ENGINEERING STUDY <input type="checkbox"/>		LAC - 92							
		CHANGE PROPOSAL <input checked="" type="checkbox"/>									
DATE 9/8/60		AFFECTS: WSPPO <input checked="" type="checkbox"/>		PROJECT <input type="checkbox"/>							
NAME OF MAJOR COMPONENT SEAT PACK		PART OR LOWEST SUBASSEMBLY ---		PART NO. & MODEL OR TYPE Q-342							
TITLE OF PROPOSAL: IMPROVED SEAT PACK ASSEMBLY											
NATURE OF PROPOSAL:											
SEE PAGE 2											
REASON FOR PROPOSAL:

### IMPROVED SEAT PACK (Q-342)

FIG. 1

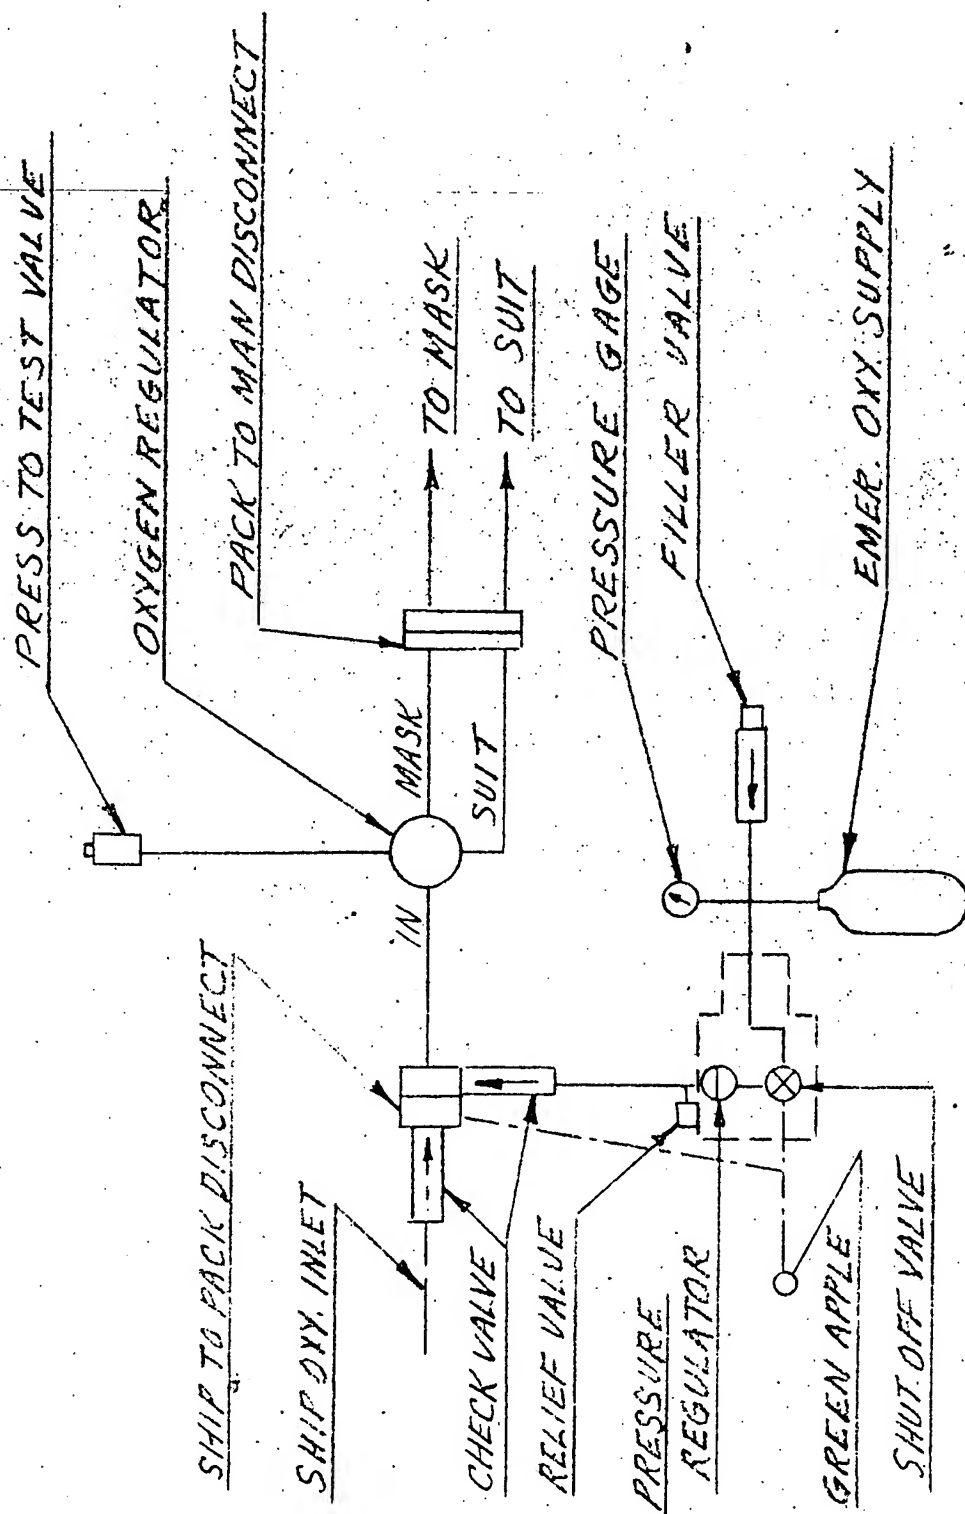
##### Oxygen System - (See Oxygen System Schematic - Figure I)

Reduced pressure oxygen is directed from the airplane system through the ship to pack disconnect. An emergency source of 96 cu. in. oxygen is supplied which is 1.7 times that in the system now in use in the existing Q-198 packs.
